ADDENDUM NO. 5

PROJECT TITLE: Law Enforcement Training Academy Barracks
Black River Technical College
Pocahontas, Arkansas

COMMISSION NUMBER: 2405

DATE OF ISSUE: September 20, 2024

M101

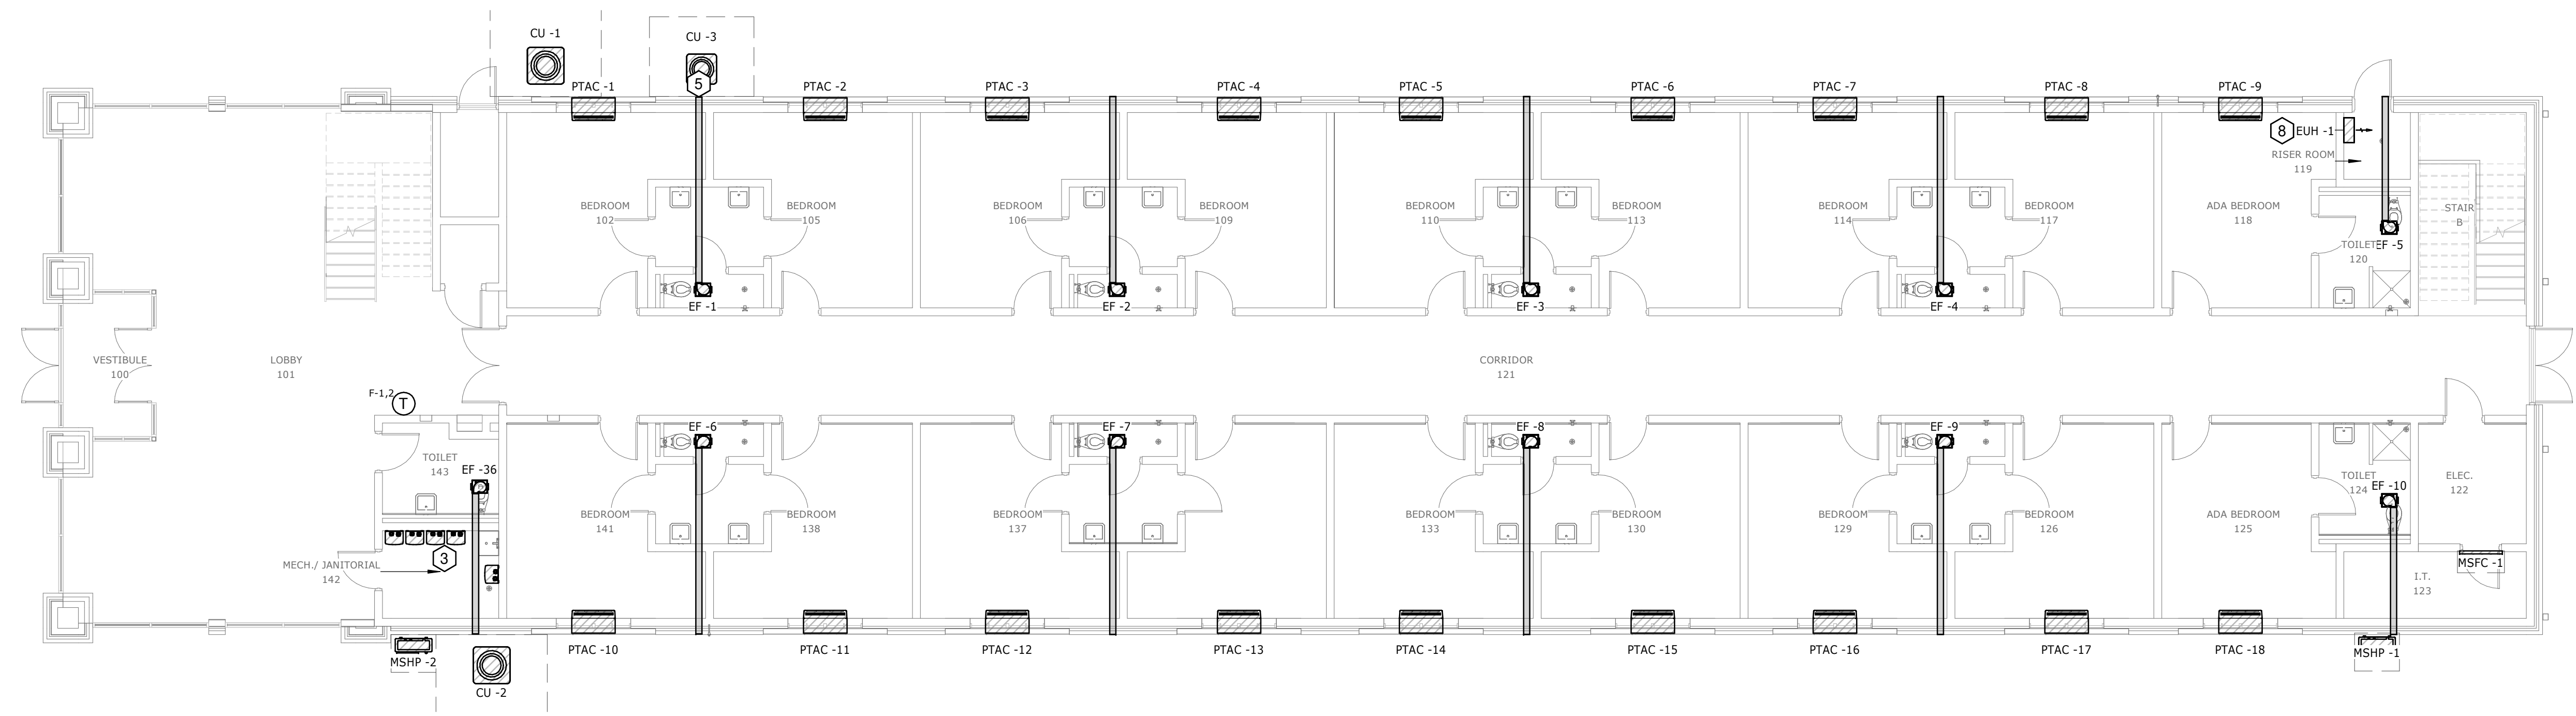
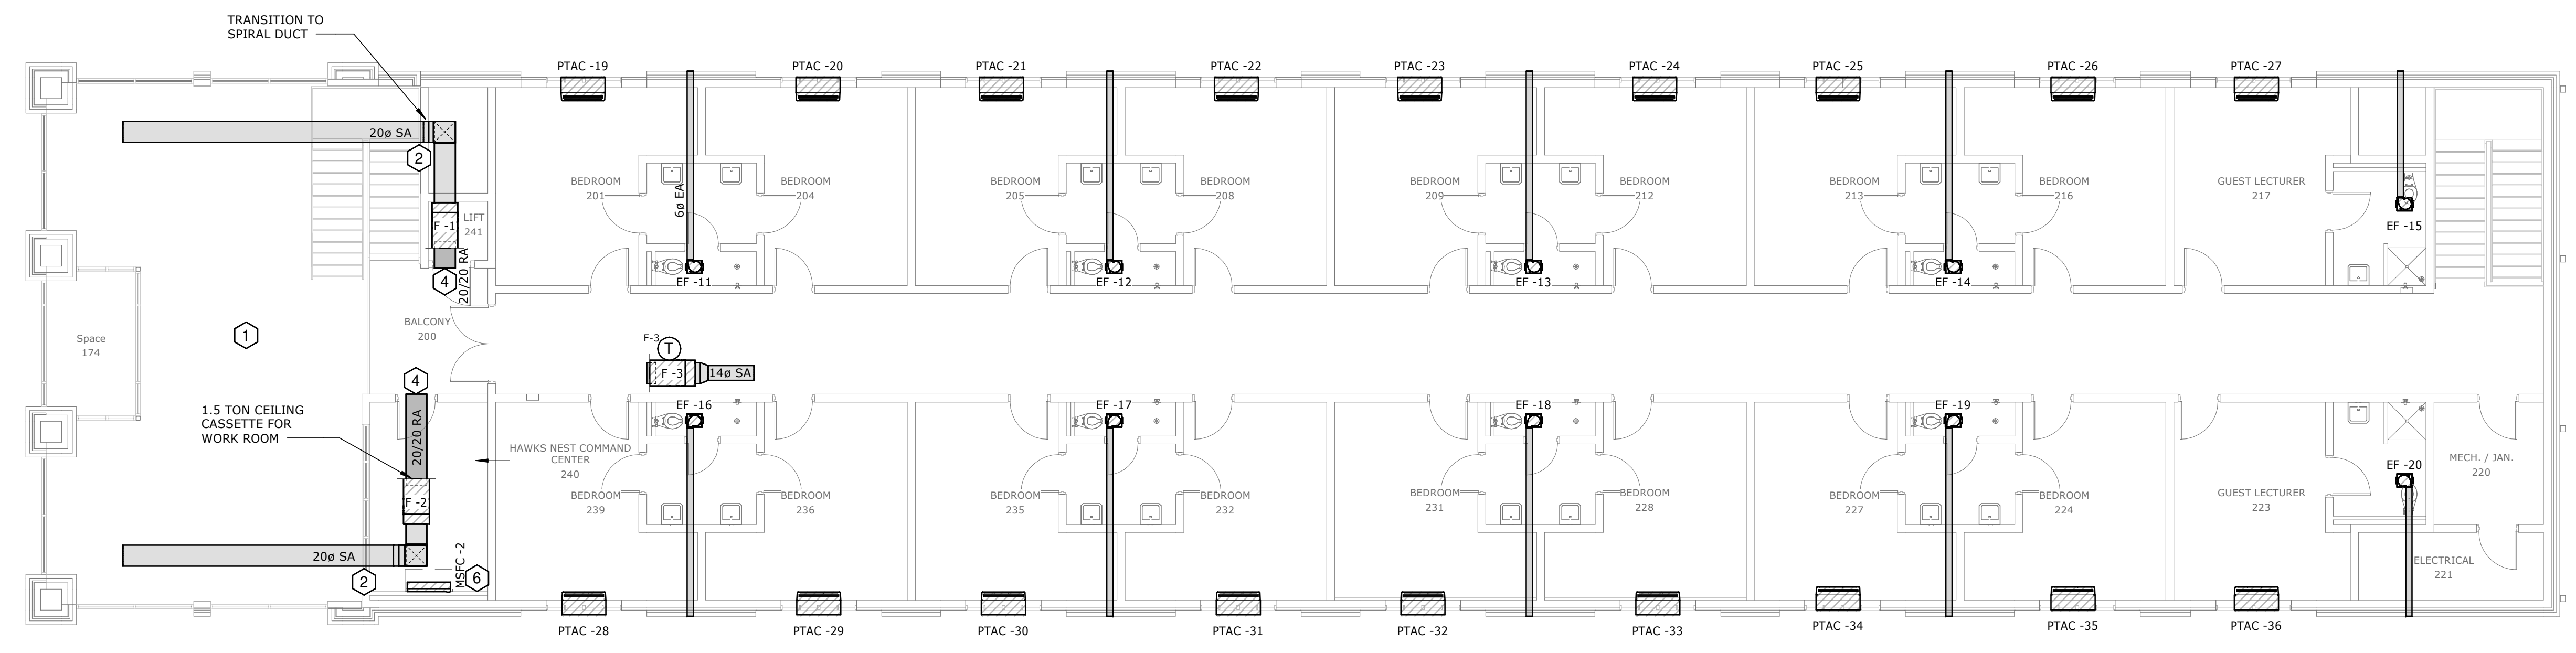
5. Drawings: Sheet M101 – HVAC Plans
 - A. Delete in its entirety and replace with page 7 of this addendum.
6. Question: 1.5 ton cassette in work room is not shown on schedule M101.

- A. There are only 2 wall mounted fan coil systems.
7. Question: General note 33 requires duct pressure test. Is this actually required? System required certified air duct test and balance, why would both be required?

- A. A pressure test shall not be required for design pressures.
8. Question: On Sheet M101 there is a notation pointing to F-1 stating to transition to spiral duct, however there is also a keyed note indicating fabric duct. Which is the correct material metal spiral or fabric? If metal spiral, what is the number and type of grills to be utilized?

- A. Keyed note 2 indicates fabric duct requirement.
9. Question: On Sheet M101 concerning F-3 are we to assume open ended supply duct with no grill? And open return with no grill?

- A. Yes, intent is for furnace to be hard ducted for a few feet for better throw and terminate open.
